ADDENDUM NO. 3

PROJECT NAME: FIRE STATION # 52

ADDENDUM NO. 03

To the drawings and specifications for:
Fire Station 52
10440 Quintana Road

A7.1

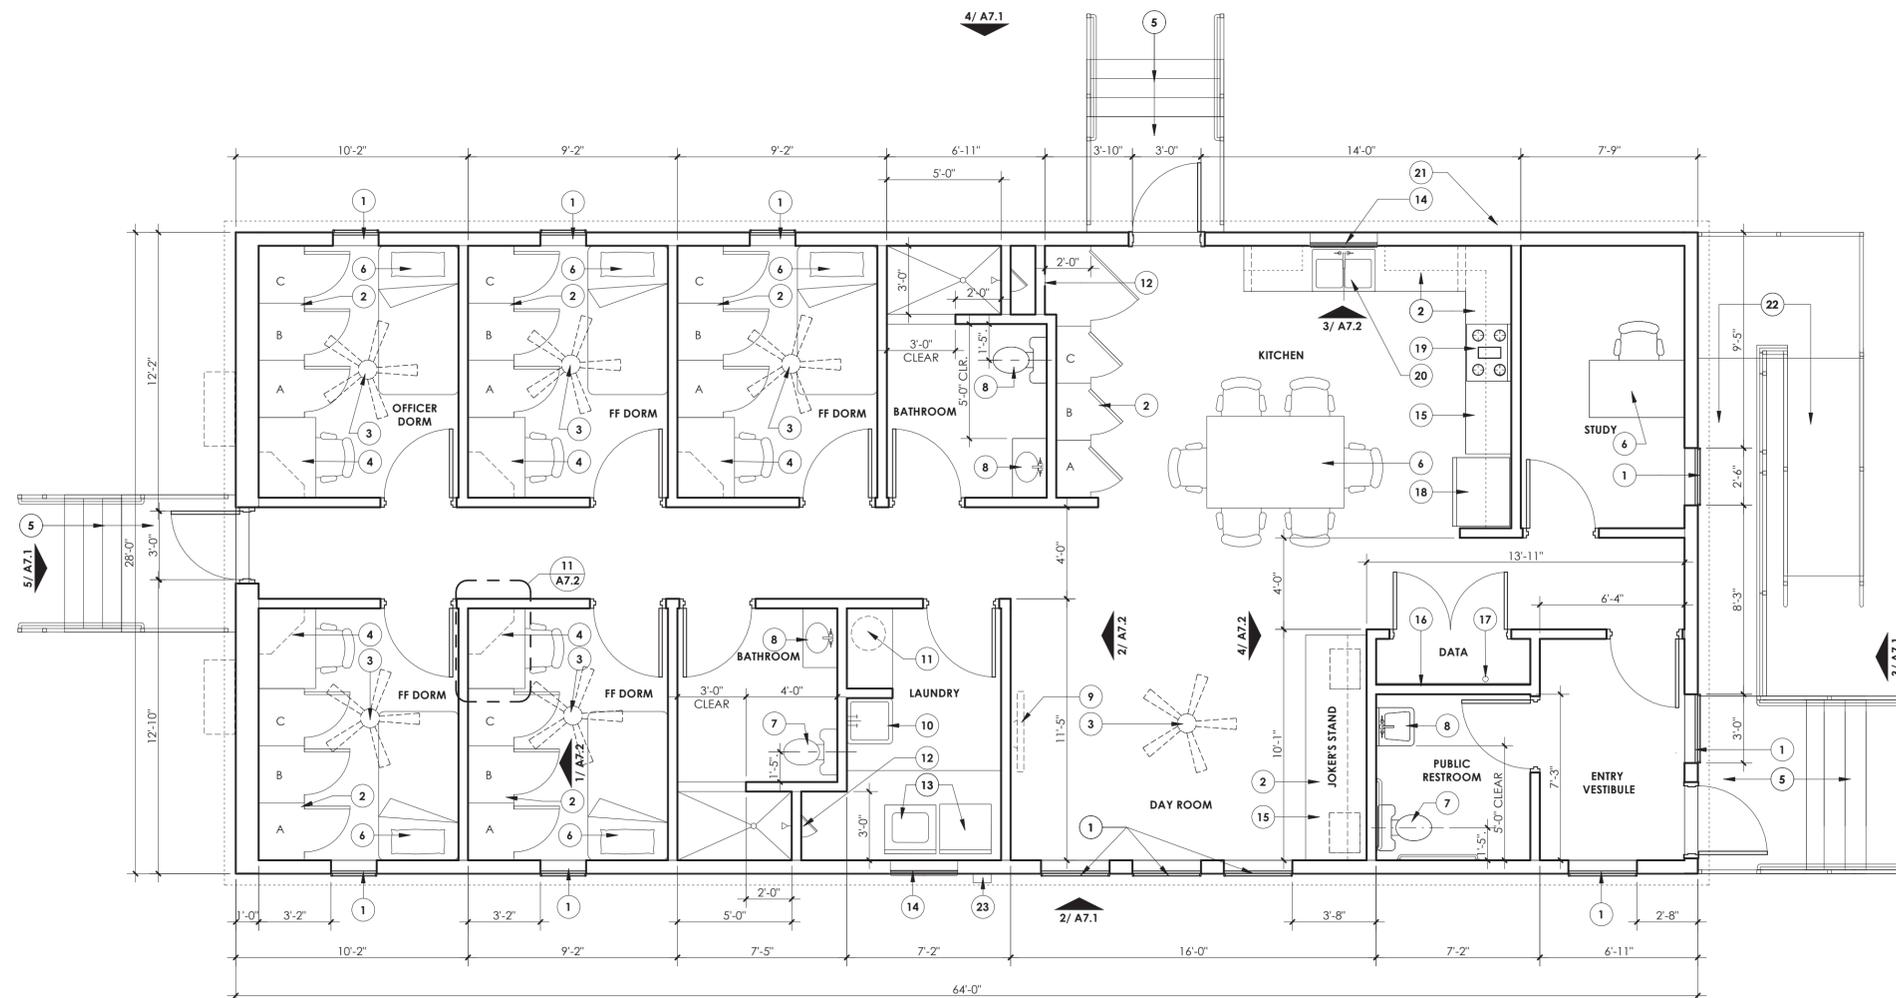
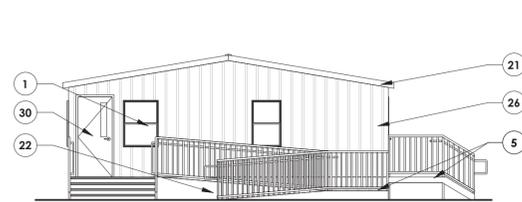
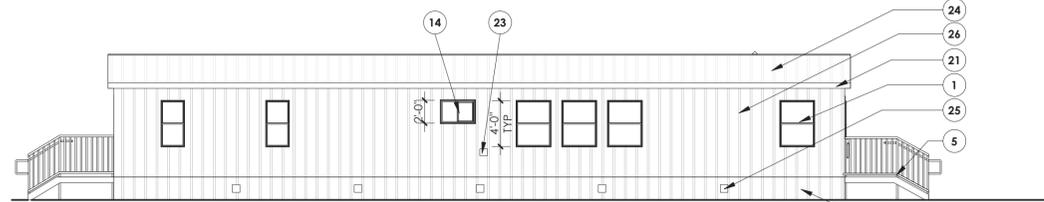
- 3.1 Alternate No. 3 has been added to the construction drawings. For Alternate No. 3, "include the amount to be added to or deducted from the base bid for the provision and installation of a state certified modular building in lieu a manufactured mobile home as indicated in the Construction Documents." Refer to attached Architectural Drawings A7.1, A7.2 & A7.3 seal dated 05.20.2016.
- 3.2 The Bid Form has been updated to include Alternate No. 3.
- 3.3 Sheets A6.1 & A6.2 have been updated to co-ordinate the outline specifications with the revised Bid Form.

A. THE A7 DRAWING SHEETS DESCRIBE THE WORK ASSOCIATED WITH ALTERNATE NO. 3 AS IDENTIFIED IN ADDENDUM NO. 3. THESE SHEETS DEPICT A MODULAR BUILDING SCOPE. MODULAR BUILDINGS AND THEIR CONSTRUCTION ARE REGULATED BY THE STATE OF TEXAS AND FALL UNDER THE TEXAS INDUSTRIALIZED BUILDING CODE COUNCIL. THESE SHEETS DEPICT GENERAL DESIGN SCOPE FOR THE PURPOSE OF BIDDING AND NEGOTIATION AND ESTABLISH THE BASIS FOR DELEGATED DESIGN SCOPE. THEY DO NOT COVER ALL ASPECTS OF THE MODULAR BUILDING REQUIRED FOR CONSTRUCTION AND STATE CERTIFICATION(S). MODULAR BUILDING CONSTRUCTION DOCUMENTS ARE THE RESPONSIBILITY OF THE MODULAR BUILDING MANUFACTURER/INSTALLER AND THEIR REGISTERED PROFESSIONAL ENGINEER OR ARCHITECT. REFER TO SPECIFICATION SECTION 131650 FOR ADDITIONAL MODULAR BUILDING INFORMATION ON DELEGATED DESIGN.
